Access Compliance Report

Public Rights-of-Way

Intersection ID: 6371	Main Street: CENTURY_OAKS_LN	Cross Street: STONEY_CREEK_LN	Location: E
ADA ID: 1867A5046F41	Ramp Type: BlendTrans1	Initial Pass/Fail: Fail	Overall Compliance: No
		Severity Score: 10

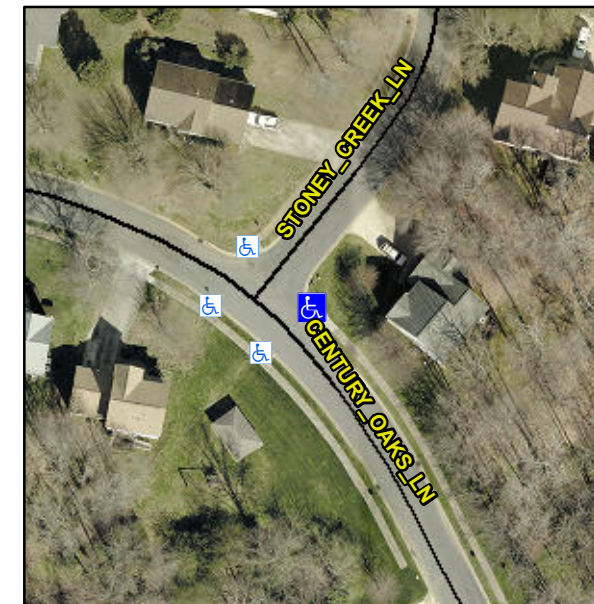
Not Found, R304.5.1, R304.5.3

Compliance	Description	Data	Compliance	Description	Data
N/A	Ramp Length (in)	44.0	Yes	BlendTrans Slope (%)	3.1
No	Ramp Width (in)	41.0	No	BlendTrans XSlope (%)	4.0
N/A	Flare Type LT	N/A	N/A	Flare Type RT	N/A
N/A	Flare Slope LT (%)	N/A	N/A	Flare Slope RT (%)	N/A
N/A	Flare Traversable LT?	N/A	N/A	Flare Traversable RT?	N/A
N/A	Landing Length (in)	N/A	N/A	DWS Provided?	N/A
N/A	Landing Width (in)	N/A	N/A	DWS Contrast?	N/A
N/A	Landing Slope (%)	N/A	N/A	DWS Length (in)	N/A
N/A	Landing X Slope (%)	N/A	N/A	DWS Full Width?	N/A
N/A	Landing Curb? (Y/N)	N/A	N/A	DWS Offset (in)	N/A
N/A	Shared Landing?	N/A			
N/A	Gutter Ponding?	N/A	N/A	Gutter Slope (%)	N/A
N/A	Gutter Lip Ht (in)	1.0	N/A	Gutter X Slope (%)	N/A
N/A	Painted X Walk1?	No	N/A	Painted X Walk2?	No
	X Walk 1 Direction	To NW		X Walk 2 Direction	To SE
	X Walk 1 Width (in)	N/A		X Walk 2 Width (in)	N/A
	X Walk 1 Slope (%)	5.7		X Walk 2 Slope (%)	1.3
	X Walk 1 X Slope (%)	1.9		X Walk 2 X Slope (%)	3.2

N/A	Ramp inside XWalk1?	N/A	N/A	Ramp inside XWalk2?	N/A
	Road Slope (%)	3.6		Clear Space?	N/A
	Road X Slope (%)	0.7	N/A	Clear Space to XWalk (in)	N/A
N/A	Any Obstructions?	N/A	N/A	Storm Grate/Utility Hazard?	N/A
	Obstruction Type			Storm Grate/Utility Type	
		N/A			N/A
			Yes	Surface Condition? (G/P)	Good
			No	Curb Slope (%)	10.7

Remove & Replace Curb Ramp With Two New Directional Ramps or Equivalent.
